Access Compliance Report

Public Rights-of-Way

(Curb Ramps)

Intersection ID: 8323	Main Street: JENNINGS_ST	Cross Street: CATHERINE_SIMMONS_AV	Location: NW
ADA ID: B0329AA31977	Ramp Type: BlendTrans2	Initial Pass/Fail: Pass	Overall Compliance: No
Codes/Mitigation Info/Possible Solution		Field Measurements/Component Compliance	
Severity Score: 2.75

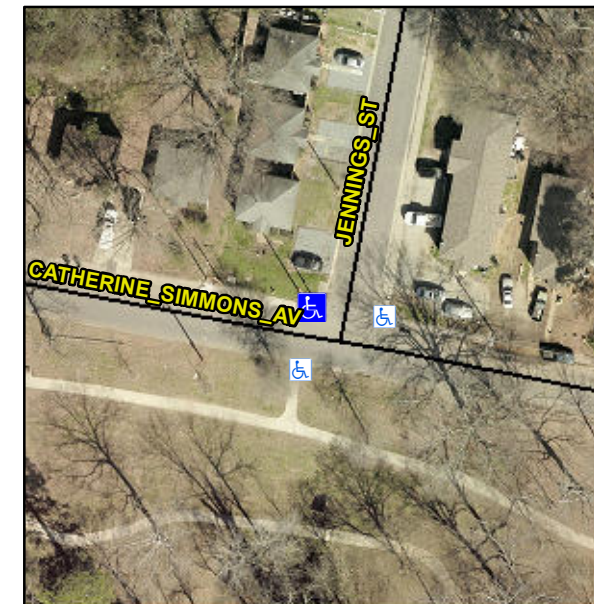
NO CURB LINE

R304.5.3, R305.1.4, R305.2

Compliance	Description	Data	Compliance	Description	Data
N/A	Ramp Length (in)	48.0	Yes	BlendTrans Slope (%)	4.5
Yes	Ramp Width (in)	96.0	No	BlendTrans XSlope (%)	3.8
N/A	Flare Type LT	None	N/A	Flare Type RT	None
N/A	Flare Slope LT (%)	N/A	N/A	Flare Slope RT (%)	N/A
N/A	Flare Traversable LT?	N/A	N/A	Flare Traversable RT?	N/A
N/A	Landing Length (in)	N/A	Yes	DWS Provided?	Yes
N/A	Landing Width (in)	N/A	Yes	DWS Contrast?	Yes
N/A	Landing Slope (%)	N/A	Yes	DWS Length (in)	24.0
N/A	Landing X Slope (%)	N/A	No	DWS Full Width?	No
N/A	Landing Curb? (Y/N)	No	No	DWS Offset (in)	5.0
N/A	Shared Landing?	No			
Yes	Gutter Ponding?	No	Yes	Gutter Slope (%)	1.6
Yes	Gutter Lip Ht (in)	0.0	No	Gutter X Slope (%)	2.4
N/A	Painted X Walk1?	No	N/A	Painted X Walk2?	No
	X Walk 1 Direction	To S		X Walk 2 Direction	To E
	X Walk 1 Width (in)	N/A		X Walk 2 Width (in)	N/A
	X Walk 1 Slope (%)	1.7		X Walk 2 Slope (%)	1.2
	X Walk 1 X Slope (%)	0.7		X Walk 2 X Slope (%)	3.4

Remove & Replace Curb Ramp With Two New Directional Ramps or Equivalent. Remove & Replace Gutter.
